Access Compliance Report

Public Rights-of-Way

(Curb Ramps)

Intersection ID: 43691	Main Street: PORTSTEWART_LN	Cross Street: TEW_CT	Location: NW
ADA ID: B5B1777580CA	Ramp Type: BlendTrans1	Initial Pass/Fail: Fail	Overall Compliance: No
Codes/Mitigation Info/Possible Solution			Severity Score: 10
			Field Measurements/Component Compliance

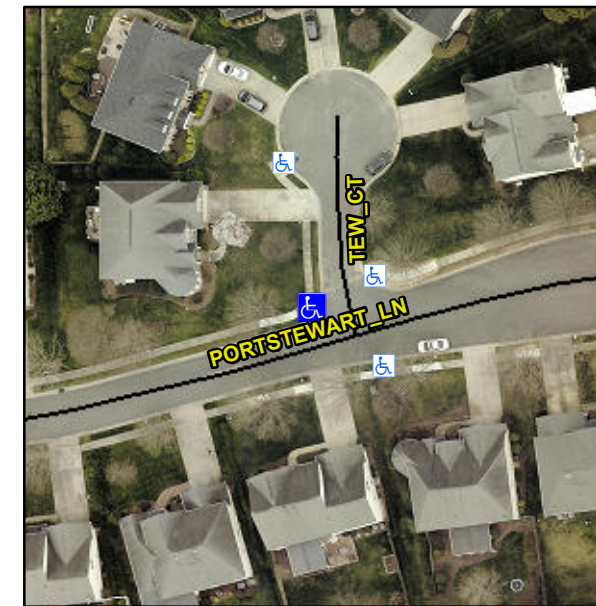
Not Found, R304.5.1, R304.5.3

Compliance	Description	Data	Compliance	Description	Data
N/A	Ramp Length (in)	47.0	Yes	BlendTrans Slope (%)	4.1
No	Ramp Width (in)	41.0	No	BlendTrans XSlope (%)	3.9
N/A	Flare Type LT	N/A	N/A	Flare Type RT	N/A
N/A	Flare Slope LT (%)	N/A	N/A	Flare Slope RT (%)	N/A
N/A	Flare Traversable LT?	N/A	N/A	Flare Traversable RT?	N/A
N/A	Landing Length (in)	N/A	N/A	DWS Provided?	N/A
N/A	Landing Width (in)	N/A	N/A	DWS Contrast?	N/A
N/A	Landing Slope (%)	N/A	N/A	DWS Length (in)	N/A
N/A	Landing X Slope (%)	N/A	N/A	DWS Full Width?	N/A
N/A	Landing Curb? (Y/N)	N/A	N/A	DWS Offset (in)	N/A
N/A	Shared Landing?	N/A			
N/A	Gutter Ponding?	N/A	N/A	Gutter Slope (%)	N/A
N/A	Gutter Lip Ht (in)	N/A	N/A	Gutter X Slope (%)	N/A
N/A	Painted X Walk1?	No	N/A	Painted X Walk2?	No
	X Walk 1 Direction	To S		X Walk 2 Direction	To E
	X Walk 1 Width (in)	N/A		X Walk 2 Width (in)	N/A
	X Walk 1 Slope (%)	2.0		X Walk 2 Slope (%)	4.9
	X Walk 1 X Slope (%)	6.7		X Walk 2 X Slope (%)	0.6

N/A	Ramp inside XWalk1?	N/A	N/A	Ramp inside XWalk2?	N/A
	Road Slope (%)	5.6		Clear Space?	N/A
	Road X Slope (%)	5.3	N/A	Clear Space to XWalk (in)	N/A
N/A	Any Obstructions?	N/A	N/A	Storm Grate/Utility Hazard?	N/A
	Obstruction Type			Storm Grate/Utility Type	
		N/A			N/A
			Yes	Surface Condition? (G/P)	Good
			No	Curb Slope (%)	15.3

Remove & Replace Curb Ramp With Two New Directional Ramps or Equivalent.
